Access Compliance Report

Public Rights-of-Way

(Curb Ramps)

Intersection ID: 13947	Main Street: CHERRY_ST	Cross Street: CHARLOTTETOWNE_AV	Location: SW
ADA ID: FC72EE857220	Ramp Type: Perp	Initial Pass/Fail: Fail	Overall Compliance: No
Severity Score: 25			
Codes/Mitigation Info/Possible Solution		Field Measurements/Component Compliance

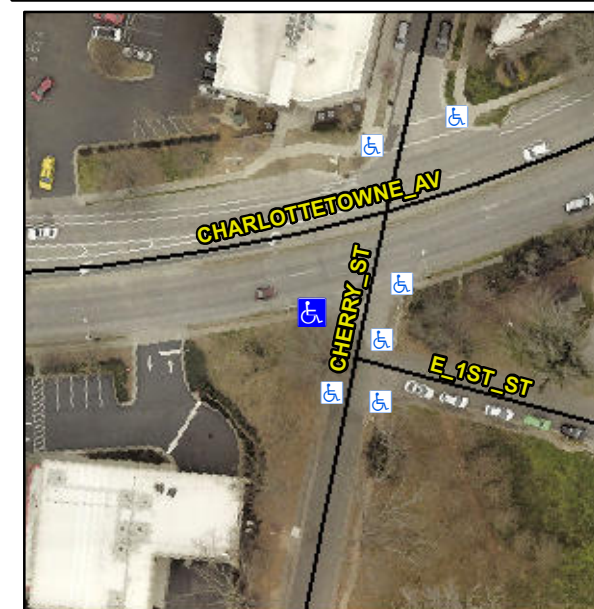
Not Found, R304.2.2, R304.5.3

Compliance	Description	Data	Compliance	Description	Data
N/A	Ramp Length (in)	48.0	No	Ramp Slope (%)	11.3
Yes	Ramp Width (in)	48.0	No	Ramp XSlope (%)	5.7
N/A	Flare Type LT	N/A	N/A	Flare Type RT	N/A
N/A	Flare Slope LT (%)	N/A	N/A	Flare Slope RT (%)	N/A
N/A	Flare Traversable LT?	N/A	N/A	Flare Traversable RT?	N/A
N/A	Landing Length (in)	N/A	N/A	DWS Provided?	N/A
N/A	Landing Width (in)	N/A	N/A	DWS Contrast?	N/A
N/A	Landing Slope (%)	N/A	N/A	DWS Length (in)	N/A
N/A	Landing X Slope (%)	N/A	N/A	DWS Full Width?	N/A
N/A	Landing Curb? (Y/N)	N/A	N/A	DWS Offset (in)	N/A
N/A	Shared Landing?	N/A			
N/A	Gutter Ponding?	N/A	N/A	Gutter Slope (%)	N/A
N/A	Gutter Lip Ht (in)	N/A	N/A	Gutter X Slope (%)	N/A
N/A	Painted X Walk1?	No	N/A	Painted X Walk2?	N/A
	X Walk 1 Direction	To E		X Walk 2 Direction	N/A
N/A	X Walk 1 Width (in)	N/A	N/A	X Walk 2 Width (in)	N/A
	X Walk 1 Slope (%)	5.8		X Walk 2 Slope (%)	N/A
	X Walk 1 X Slope (%)	2.3		X Walk 2 X Slope (%)	N/A

Remove & Replace Entire Ramp.
